Subject: Comments on the Interim Monitoring Plan Proposed for WA 30166 by El Sur Ranch to Appropriate Water from Big Sur River Subterranean Stream, Monterey County

Water Right Application No. 30166 seeks to extract ground water from underflow at the mouth of the Big Sur River. The point of diversion is two existing agricultural irrigation wells located in the flood plain northwest of the river within the Andrew Molera State Park. The El Sur Ranch (ESR) has submitted three technical documents in support of their Water Rights Application. These documents provide data and technical analyses assessing the environmental impacts from the ground water pumping on the lower reach of the Big Sur River. The two ESR agriculture wells are called the Old Well and the New Well. A third, smaller well, called the Navy Well, is operated by State Parks and Recreation Department, and pumps groundwater from the same aquifer. At the request of the Department of Fish and Game, Agreement No. P0530003, I have reviewed the three technical reports listed below. This letter presents my findings and opinions on the hydrologic, hydrogeologic and biologic data and environmental assessment presented in these rep

Figure 1

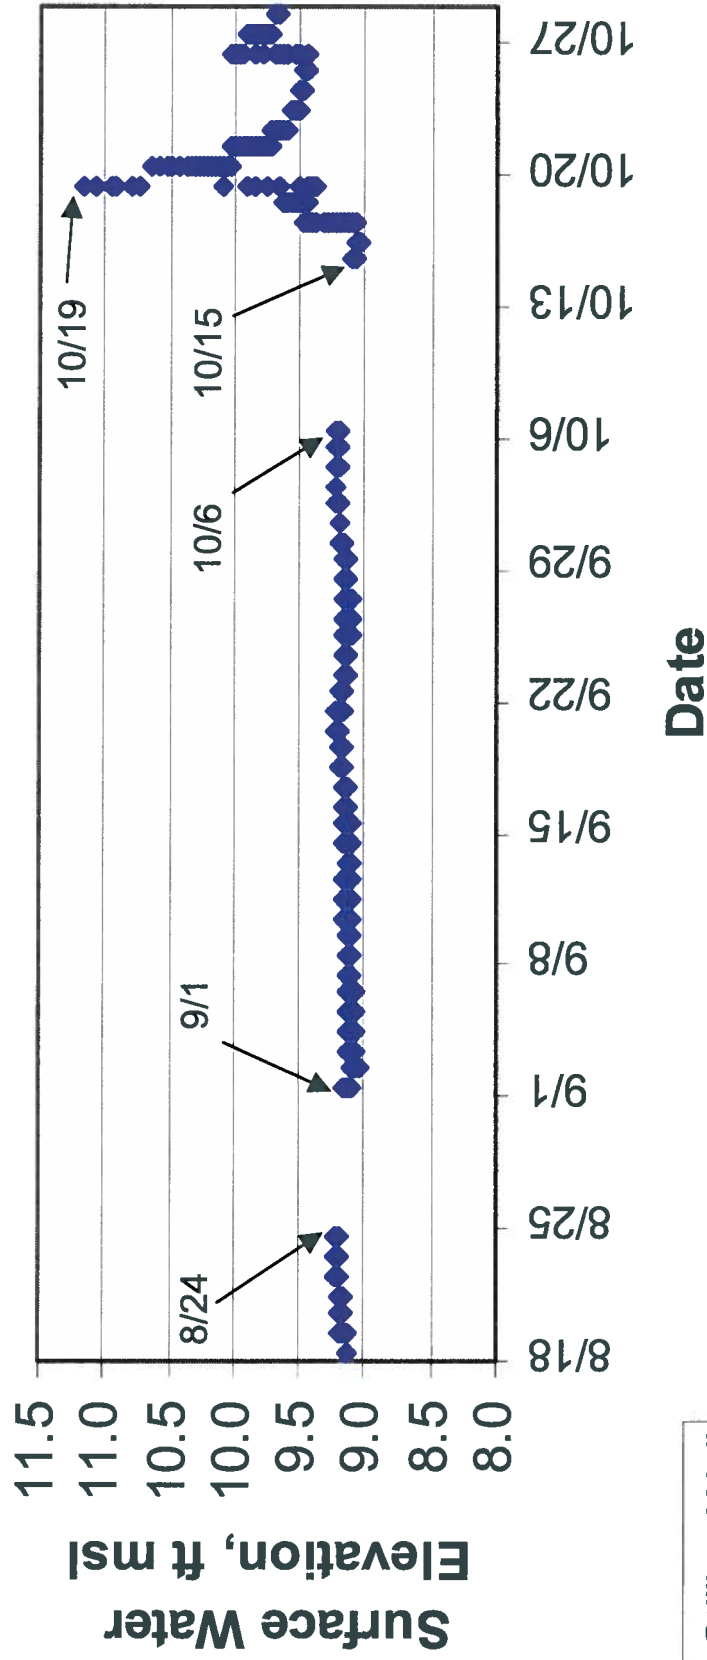
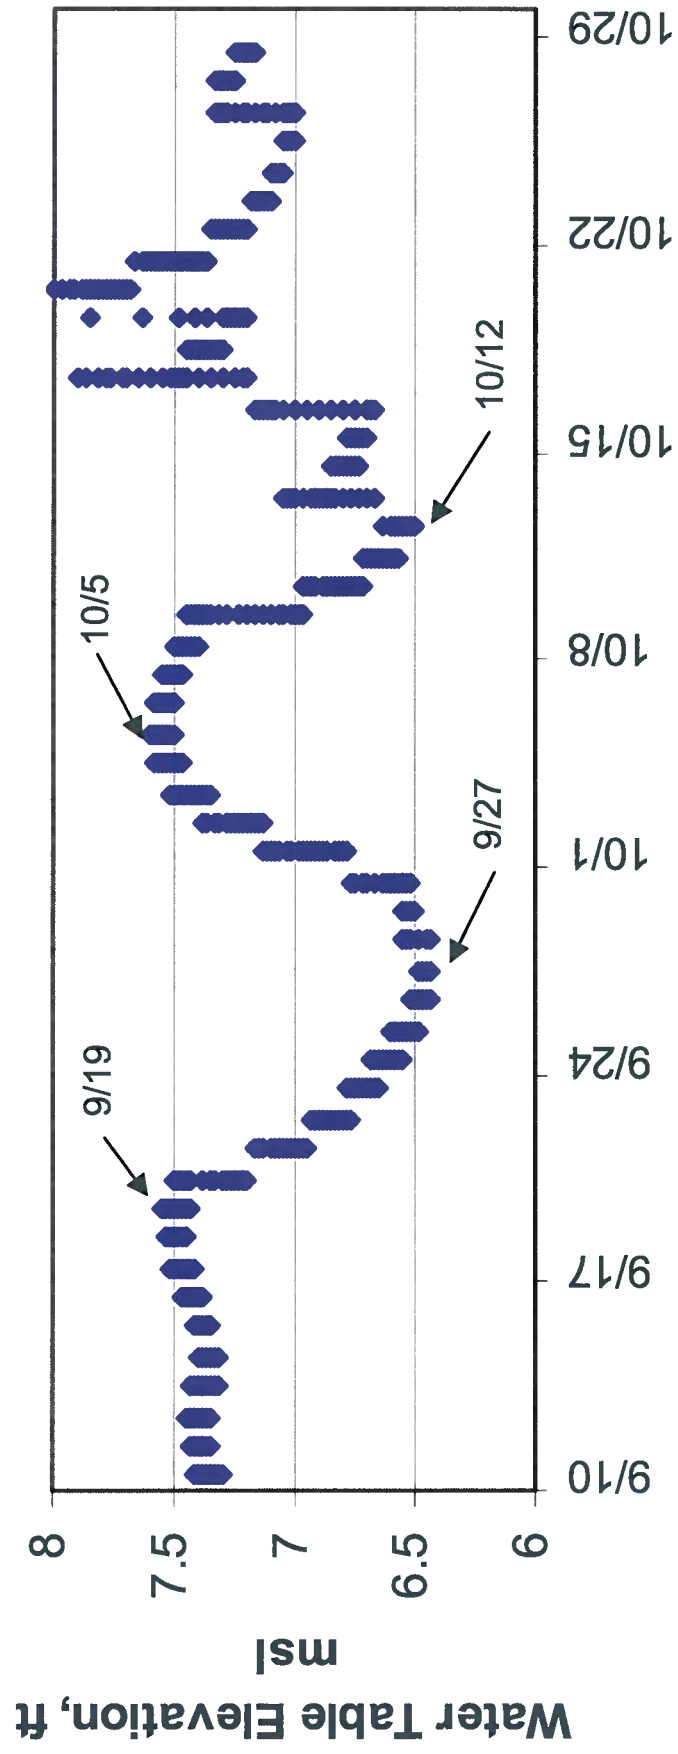
in surface water and groundwater levels as the result of increasing the pumping from one to two wells as discussed in SGI section 3.4.8.1 and as shown in SGI Figure 3-35. SGI Figure 3-35 shows the water levels dropping from mid-September to early October in 2004 at the stilling well in the river adjacent to VT #2 and in monitoring well ESR 10-B. The SGI report noted that the surface water level dropped approximately ½ inch and the ground water in the well dropped approximately 1 foot as a result of increased pumping. While this may not appear to be much of a physical change to the river, it is a significant change in hydraulic gradient between the river and well. The change in hydraulic gradient is a measure of the significance of increase, or decrease, in pumping because ground water flow is governed by Darcy's Law ( $Q = k \cdot i \cdot A$ ). Assuming the hydraulic conductivity ( $k$ ) and cross-sectional area ( $A$ ) are not significantly changed, then the change in hydraulic gradient ( $i$ ) quantifies the change and level of impact. As the Initial Study noted, ground water losses or gains to a river do not generally occur at a single point, but are spread along the river reach. Thus, the total change in flow can't be measured at a single point but must be measured between at least two points placed on either side of the impacted reach. By the statement of "no noticeable impact," the Initial Study appears to expect that the impacts from pumping the wells will be similar to a diversion into a pipe or canal, all occurring at one point on the river. The following discusses the significance of the hydraulic changes measured when the pumping rates varied.

- b. As noted above, the SGI report acknowledges that the river between VT#1 and VT#2 is a losing reach. The change in water levels at the stilling well and the increase in groundwater gradient that resulted from the increased pumping rate document that river losses from pumping can extend downstream to at least VT#2. Before September 19<sup>th</sup>, the Old Well was pumping at 2.55 cfs (see SGI Table 2-2). After the New Well began pumping, the combined rate of pumping was approximately 4.8 cfs, an increase of approximately 88%. Because the flow of ground water follows Darcy's Law, a change in groundwater flow is proportional to the change

in hydraulic gradient. With an almost doubling of the pumping rate, the hydraulic gradient between VT#2 and ESR 10-B increased approximately 50 percent (SGI Figure 3-36). This increase in gradient agrees with the analysis by Miller and Durnford (2005) that when the rate of stream depletion approaches the rate of pumping, then approximately half of the seepage occurs within a reach of stream centered on the well, the length of which is twice the closest stream-to-well distance. For the study area, the river's closest point to the New Well is approximately 500 feet away (see SGI Figure 2-2) and VT#2 is approximately the same distance upstream. Therefore, with the 88% increase in pumping rate, the hydraulic gradient of ground water increased by approximately 50%, which suggests an increase in seepage losses from the river of approximately 50%.

Figure 3

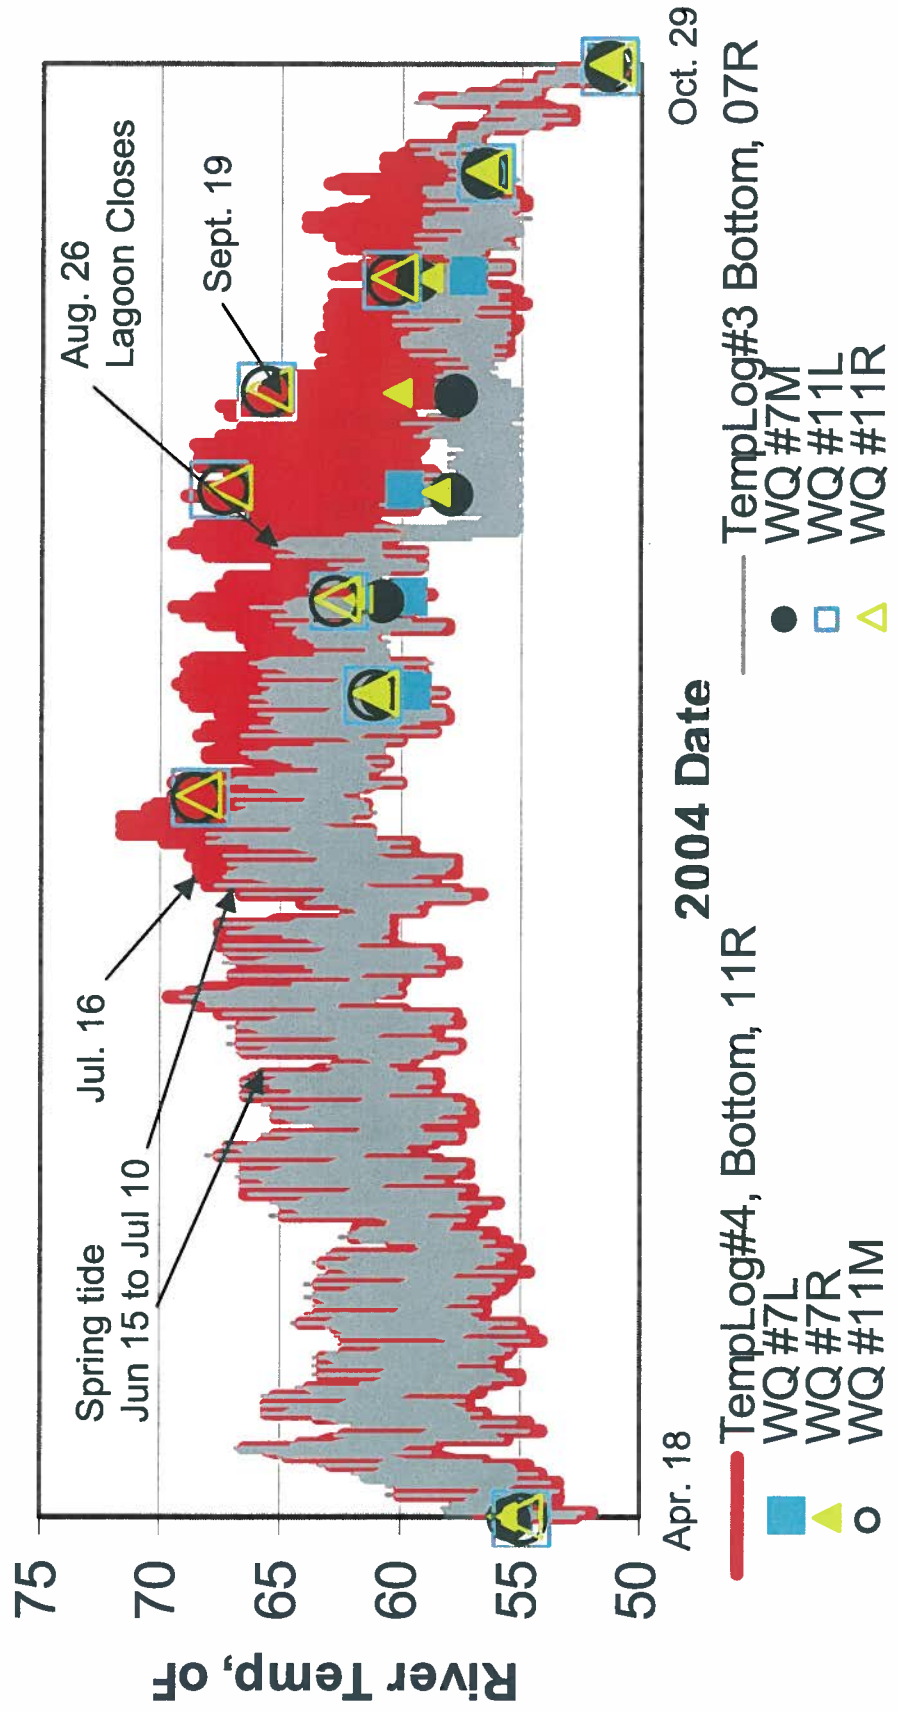
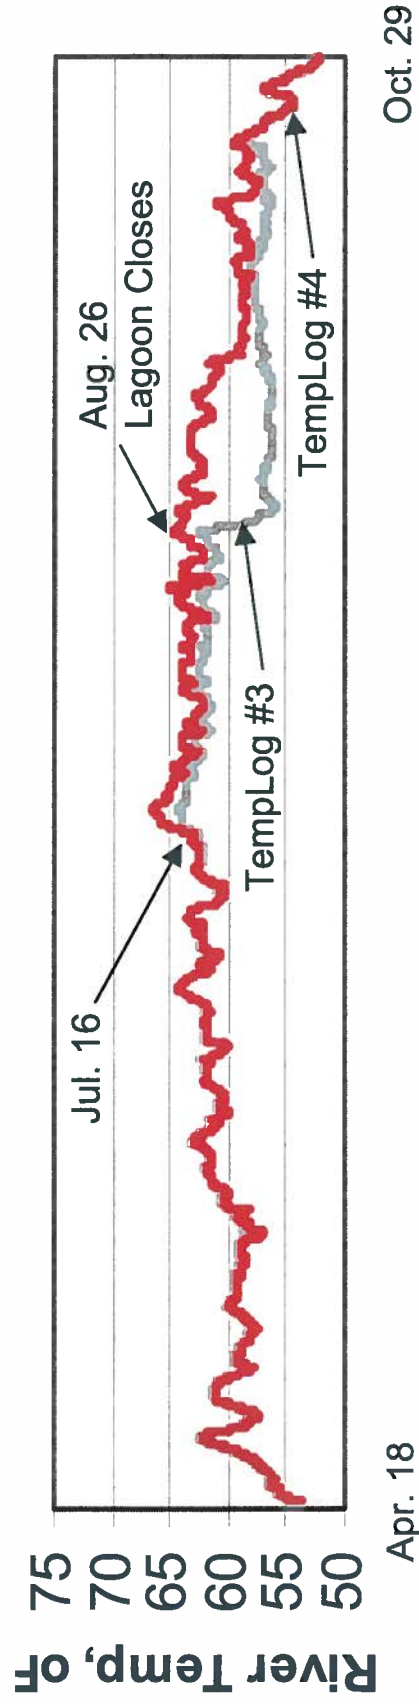
6. Periodic water quality sampling of the river was undertaken during the 2004 pumping season along the river at twenty-one sampling sites, while continuous sampling of river temperature was done at five temperature logger sites (see SGI Figure 2-2 for sampling locations). Two continuous recording temperature loggers, numbered 3 and 4, were placed in the section of river between water quality stations #12 and #6, temp-logger #3 at water quality station #7R, and temp-logger #4 at water quality station #11R. Temp-loggers #4 is in an apparent losing reach and temp-logger #3 is in an apparent gaining reach, the "cold pool." Figure 3 (attached) shows the continuous data from the upstream, bottom temp-logger #4 in red, with the downstream "cold pool," bottom temp-logger #3 values superimposed in grey. Point symbols indicate the measurements taken at adjacent water quality stations. Figure 4 shows the temperature logger data as a 24-point running average; most samples were taken hourly. These graphs show that temperatures at the two locations do not differ significantly from the beginning of the record on April 18<sup>th</sup> to approximately July 16<sup>th</sup> when a difference of 2°F to 4°F occurs for highest temperatures only. On August 26<sup>th</sup>, the lagoon closes and

the temperature differences increase for both high and low temperatures. Between September 2<sup>nd</sup> and the 20<sup>th</sup>, there is a gradual drop in the temperature at the upstream temp-logger #4. By mid-October, near the end of the record, the temperature range and variations are again similar at the two locations. Even though these temperature data were taken from the right side of the channel, the pumping well side, the data show that the differences between the hotter upstream reach and the “cold pool” were not uniform throughout the irrigation season. The questions then are why is there a variation, how consistent is the upwelling, and what impact might this have on the proposed mitigation monitoring program. The following is a discussion of the 2004 irrigation season temperature data taken by the two continuous temperature loggers, and at the adjacent water quality stations.

Figure 5

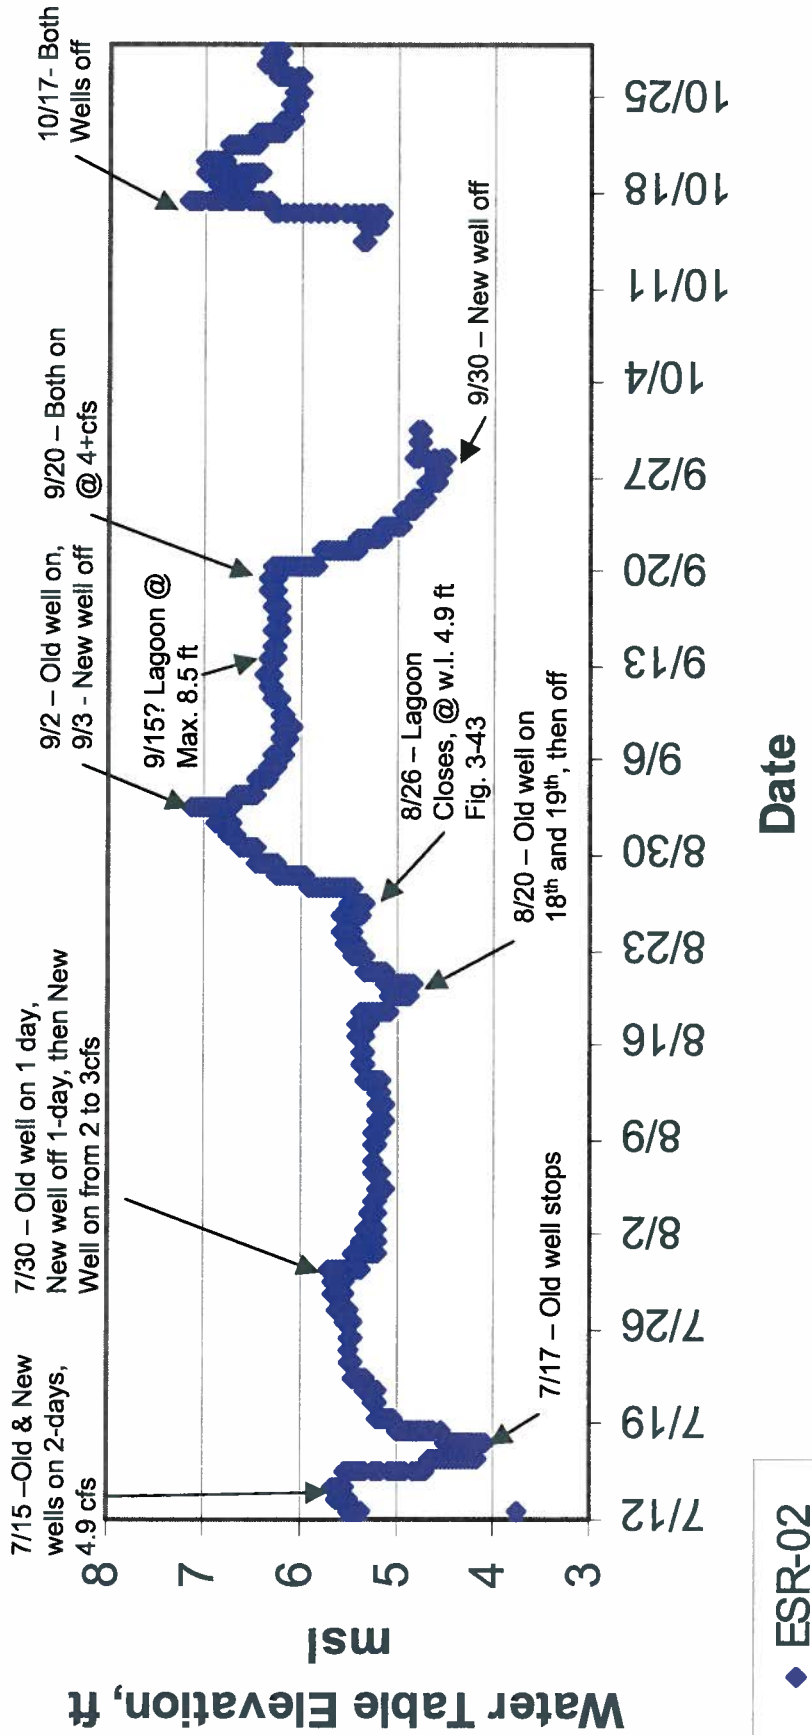
- d. On August 26, 2004, when a sand bar closes the river’s outlet, the lagoon surface water level starts rising from approximately 5.2 feet above msl and reaches 8.5 feet above msl by mid-September (see SGI Figure 3-43 and section 3.4.8.3). By the end of September, the lagoon surface drops to approximately 6.75 feet above msl. Groundwater levels in monitoring wells also go up approximately 1.5 feet to 2.0 feet by the start of September (see SGI Figure 3-44 and section 3.4.8.3). By mid-September, groundwater levels drop back to below approximately 6.25 feet above msl. The attached Figure 5 shows the changes in groundwater levels at monitoring well ESR-02 which is representative of the effects of the

lagoon closure over a longer period than shown in SGI Figure 3-44. The rise in river stage with the closure of the lagoon may have extended upstream into the reach of the “cold pool” (see SGI Figures 3-28 and 3-29 for a comparison of lagoon water levels). The evidence for this can be found in the sampling depths of the water quality stations.

Figure 6

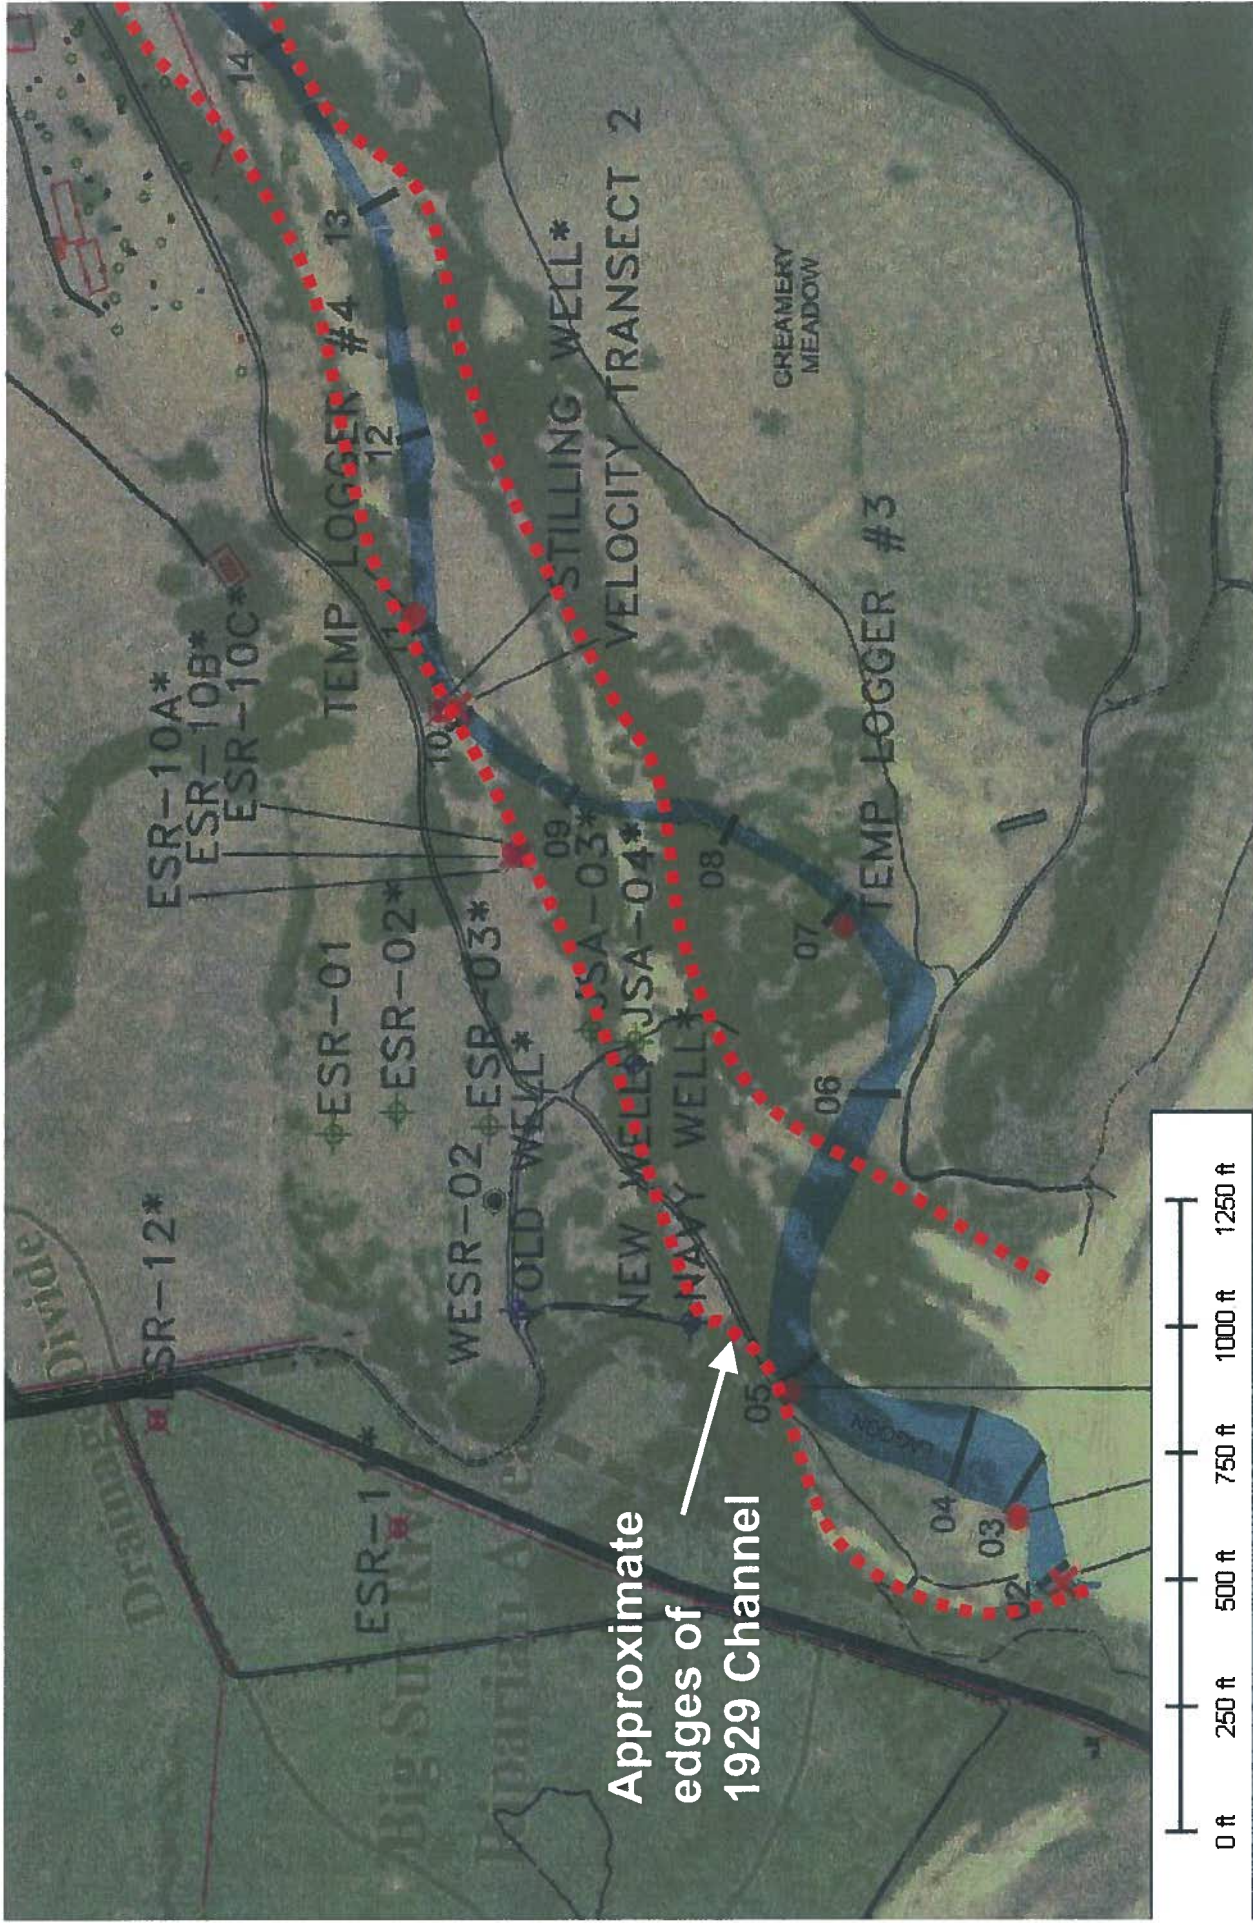
- h. **Review of historic aerial photos and topographic maps.** Figure 9-1 of the May 18, 2005 NRCE water use report shows the study area in 1929. A comparison of the 1929 river configuration to that of today (see attached Figure 6) clearly shows that today's sinuous channel next to the pumping wells was instead rather linear and a somewhat braided reach. This change in channel morphology may be an important feature in determining where to monitor, and may help explain the movement of ground water because the main channel of a river is often coarser grained than bank deposits and becomes a preferred flow path. Historic photos, aerial or ground based, would be a valuable source to document historic changes in channel morphology. Knowledge of any changes in the channel is critical in interpreting the existing data and in selecting monitoring points for the water rights permit. An effort should be made to collect and analyze these.
